Batch 4 drawn, and one question: her study's turret, the hospital wing, the Defence rooms, the Potions dungeon

The Architect, 14 October 2026, for Godric. Ledger lines 16 to 18 and req 332 (docs/architect/changes.md), drawn from the castle model, version 21. Red: what changes. Page 2: the library as taken, the doors' passage, the stair hall's roof.

Batch 4, page 2: the library as taken, the Great Hall's doors, the stair hall's roof

The Architect, 14 October 2026, for Godric. Ledger lines 13 to 15, drawn from the castle model, version 21. Red: what changes.

Q 1 (and 3): the study as the model holds it, floor 7 (1:250)

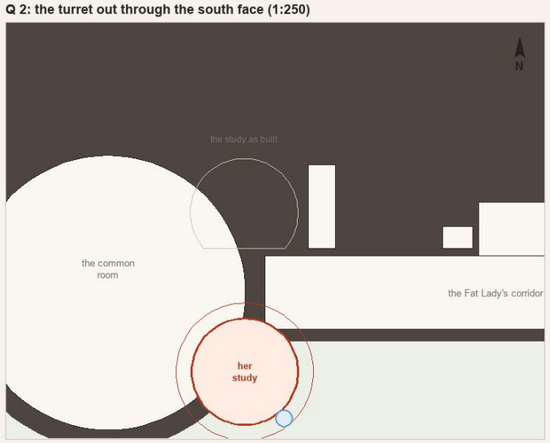
Req 332's question: the Corridor's Q33 touches t1 and t2

Her study stands inside the south range at floor 7 (x 45.5 to 49.9, y 3.0 to 7.4), north of the corridor, under the range's lead flat: it has no outside face, and her window (req 253) is enchanted and blind to the wall behind it. So t1 (its one small lit window seen from outside) and t2 (the lion's head under the corbel, seen looking down from her window) cannot stand as written (docs/archive/corridor-to-2026-10-12.md, Her study, pulled to the tower).

1, recommended: keep t1 and t2 as ideas for later, not built; nothing moves. 2: move the turret out through the south face, so both can stand; the corridor's west end, the bookcase wall and the suite's pages move with it. 3: lose them. 1 and 3 draw the same.

Line 16: floor 1, the east range (1:500)

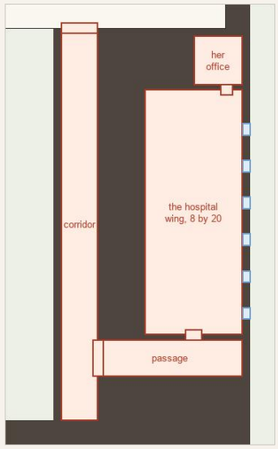
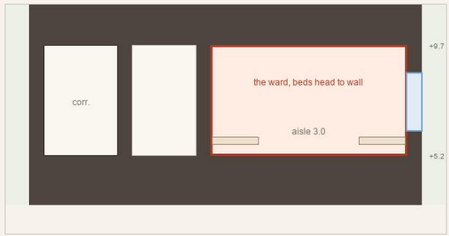
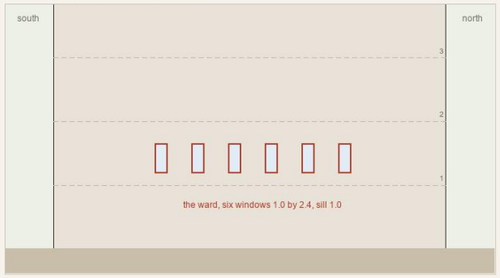
16, the hospital wing (req 333): the ward 8 by 20 on floor 1 in the east range, its door that locks off a passage, six east windows, her office beyond the far wall; the floor ours (GoF 36 and OotP 32 held).

Line 17: floor 2 (1:500)

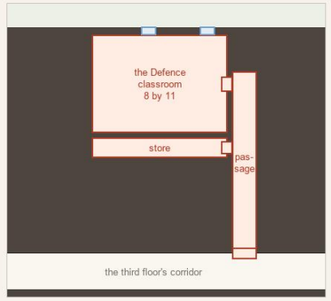
17, the Defence rooms (req 336): the office off the second floor's corridor by the stair hall; the classroom on 3 over the hall, its door at the back off a passage, two north windows, the first by the back row, a store.

Line 18: the dungeons (1:500)

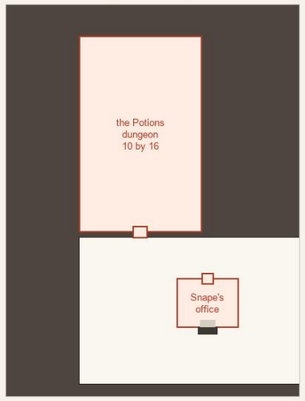
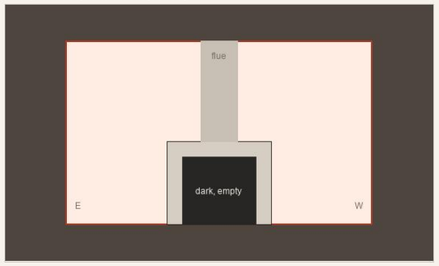
18, the Potions dungeon (req 341): 10 by 16, its door at the back, no windows, 4.0 clear; Snape's office a few steps along the passage, its cold fireplace.

Line 13: floor 4, the library (1:500)

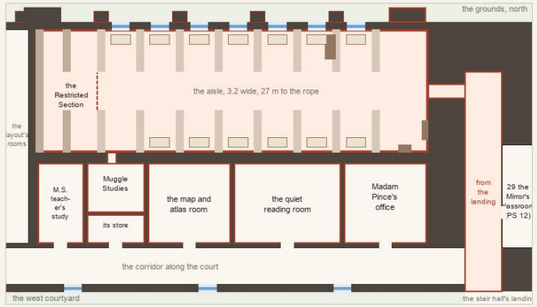
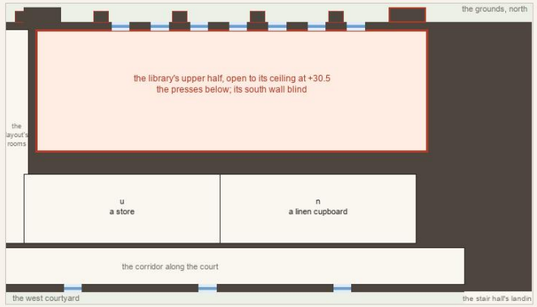
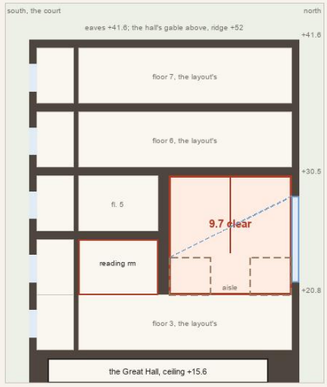
13, the library (Q17's 1, taken 12.58 am, provisional, Godric to confirm): two storeys on floors 4 and 5 over the Great Hall, 32 by 10, 9.7 clear, a window 1.4 by 7.0 in each north bay; its door through the 3 m wall off a corridor over the Entrance Hall; its band of rooms, the Muggle Studies room behind the small door, the Muggle Studies teacher's study. The north face: the hall's buttresses re-spaced to every second press (6.4) and its breast moved to x 61.8 to 64.8, so no window meets one; the massing drawing follows.

Line 14: the doors' passage, floor G (1:250)

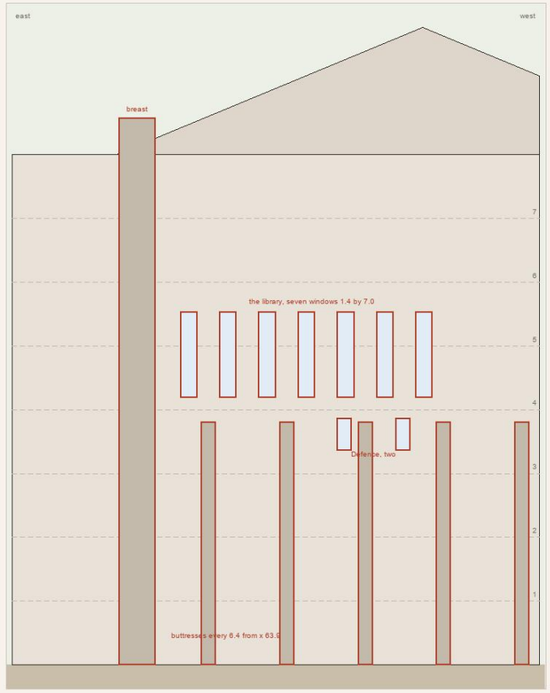
14, the Great Hall's doors (Q16's 1, provisional): the 3 m wall stays, the doors open into a vaulted passage 3.2 wide through it, the leaves at its Entrance Hall face; the broom cupboard keeps its place in the wall.

Line 15: the stair hall cut at x 80, looking west (1:500)

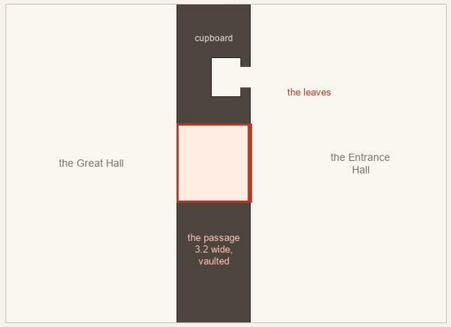
15, the stair hall's roof: the hip over the well (eaves +46, ridge +56), open beneath, the keep's lead flat at +47 to the south, the lantern astride the ridge; the awe stand's +75 kept.
